APPEAL SUMMARY

Appeal ID: 18782	Project Address: 111 SW Naito Pkwy
Hearing Date: 12/19/18	Appellant Name: Sara Ruzomberka
Case No.: B-005	Appellant Phone: 503-896-5360
Appeal Type: Building	Plans Examiner/Inspector: Gail Knoll; Megan Sita Walker
Project Type: commercial	Stories: 4e Occupancy: B Construction Type: III-B
Building/Business Name:	Fire Sprinklers: Yes - under canopy
Appeal Involves: Erection of a new structure	LUR or Permit Application No.: 18-255157-LU
Plan Submitted Option: pdf [File 1]	Proposed use: Screening and Protection of trash/recycling and mechanical equipment.

Re: Land Use Review LU 18-255157 HR – Smith Block Enclosures, Mechanical Unit, and Awnings

A3.01

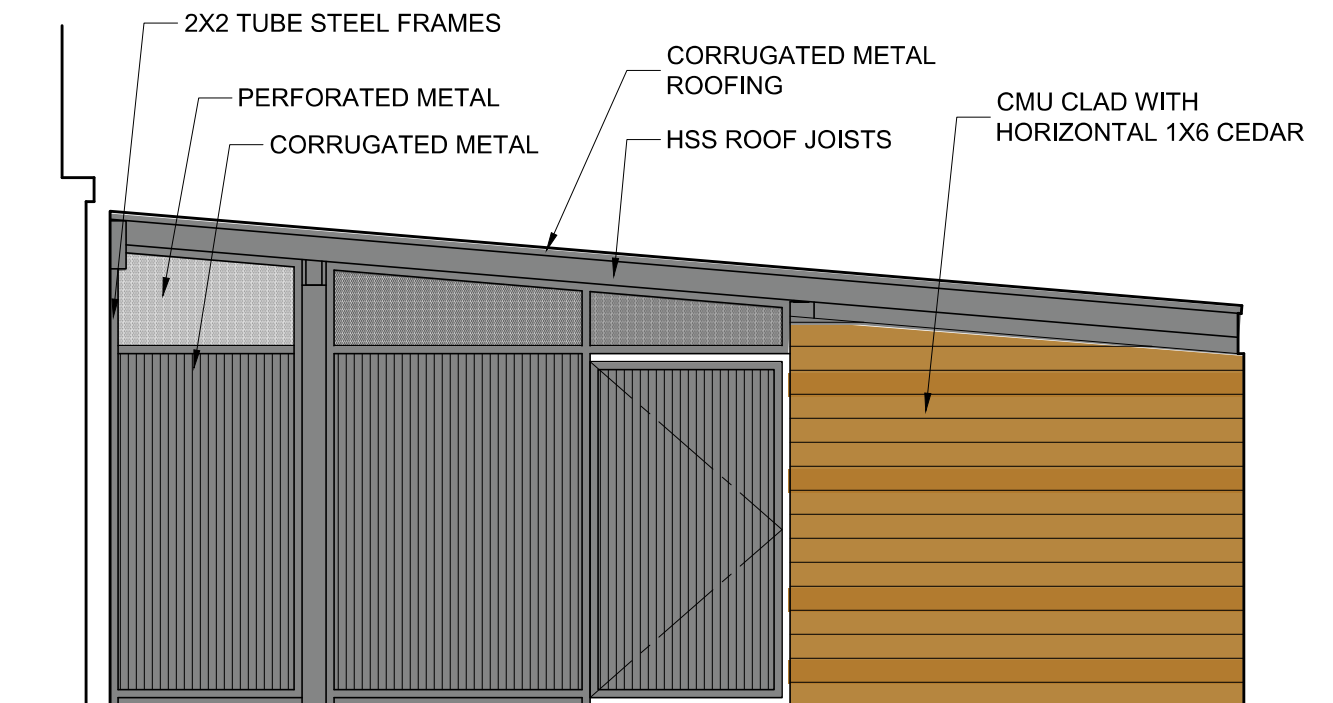
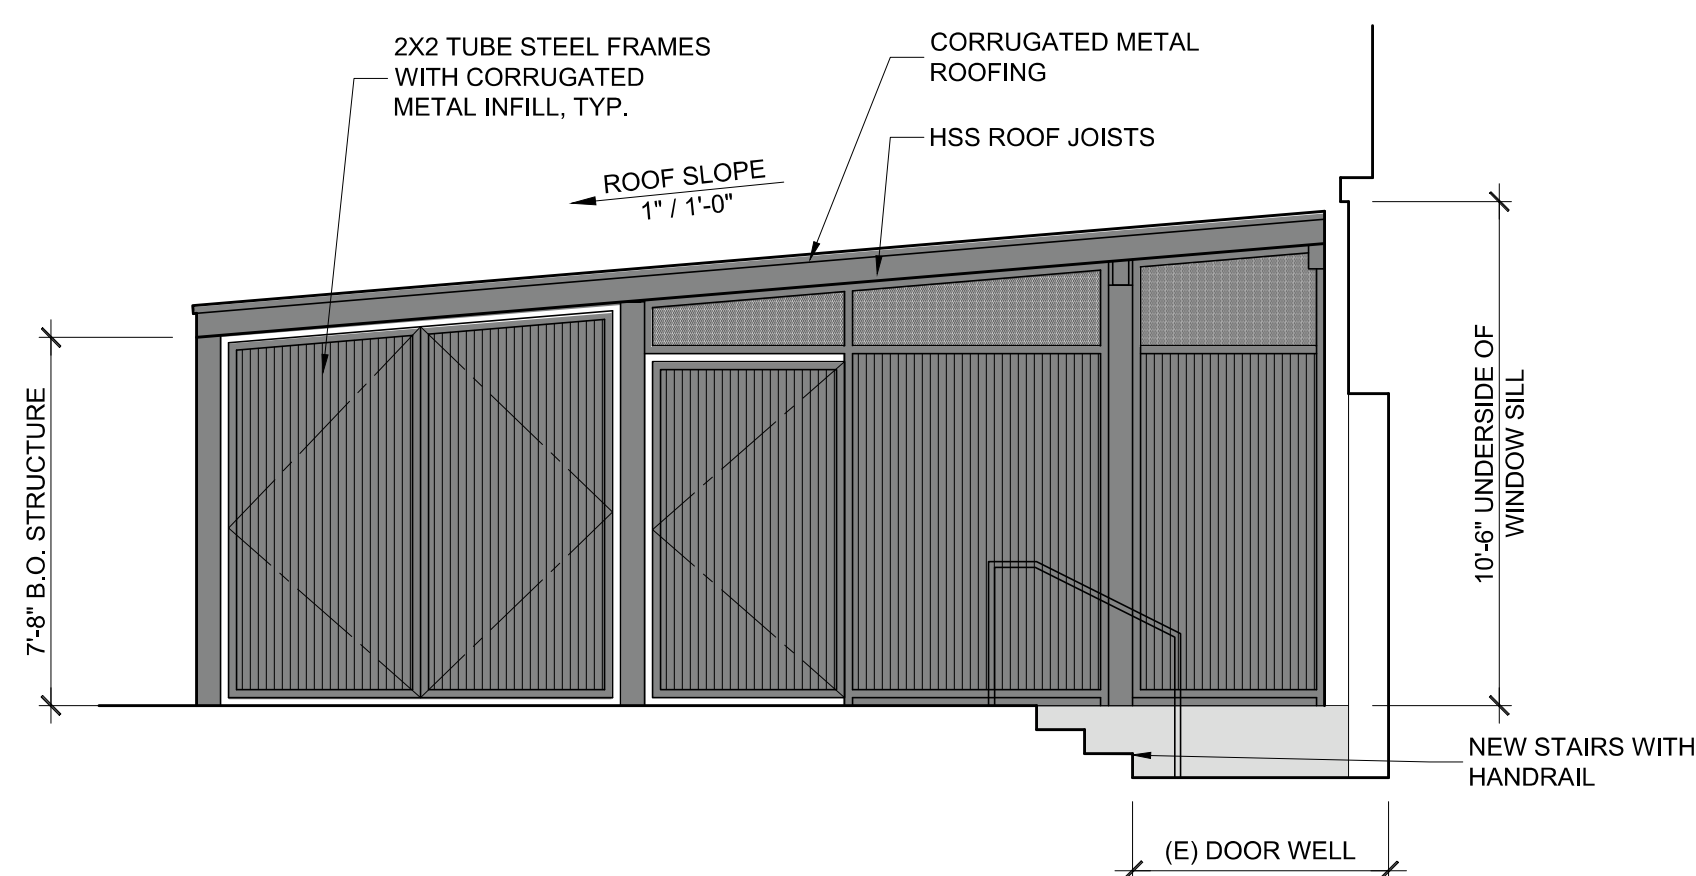
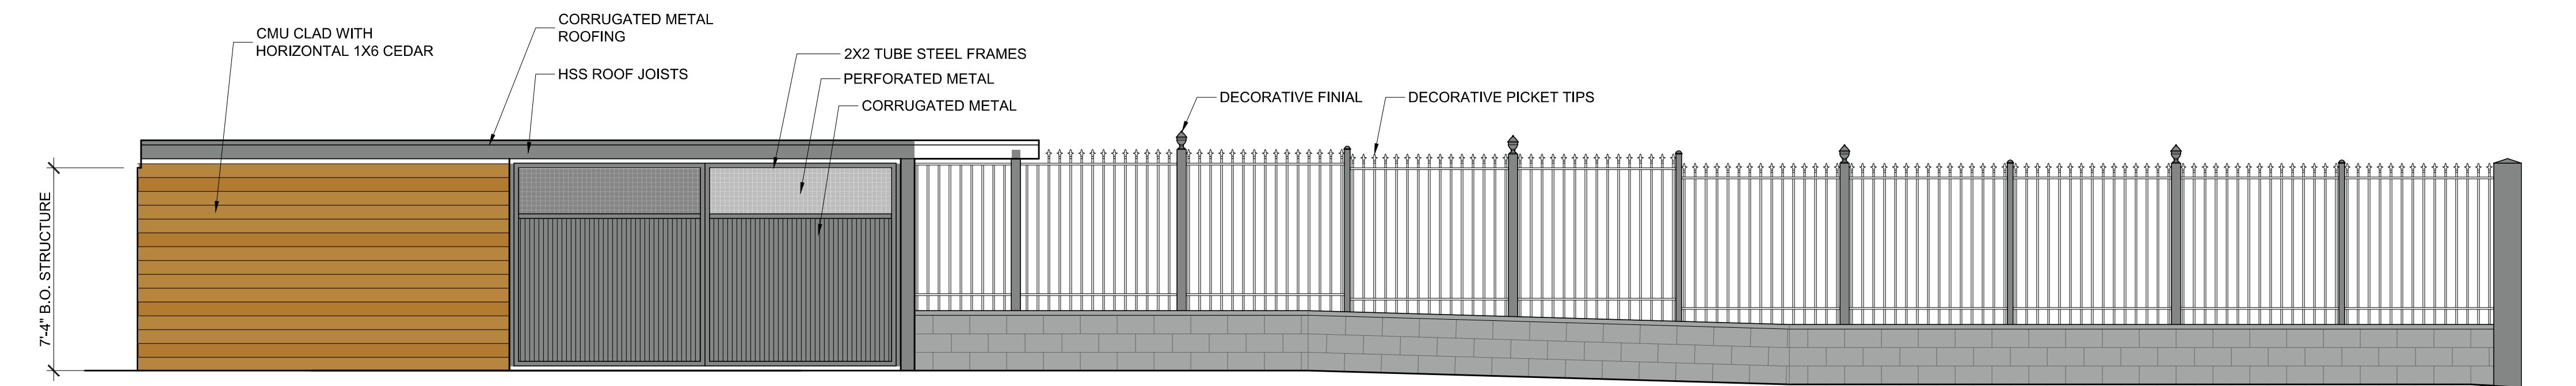
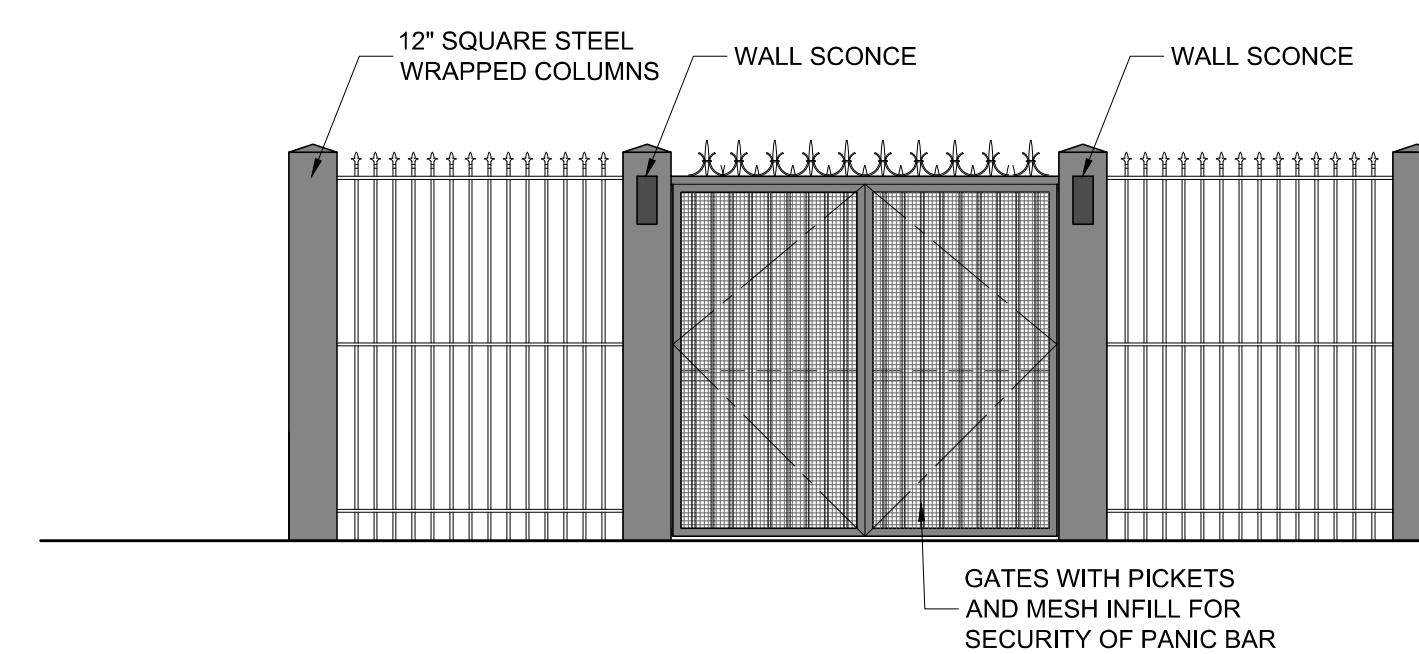
- c) **Proposed Materials** – Based on the information provided, the materials proposed do not adequately address the approval criteria. Specially, the corrugated metal, cedar clad CMU, and exposed CMU do not meet: *Skidmore/ Old Town Historic District Design Guidelines, Guidelines A4 Materials and Color, D8 Rich Detail and Quality Construction; Central City Fundamental Design Guidelines, Guidelines C2 Promote Quality and Permanence in Development, C5 Design for Coherency, or PZC, 33.846.060.G* Other approval criteria, #8 or #10.
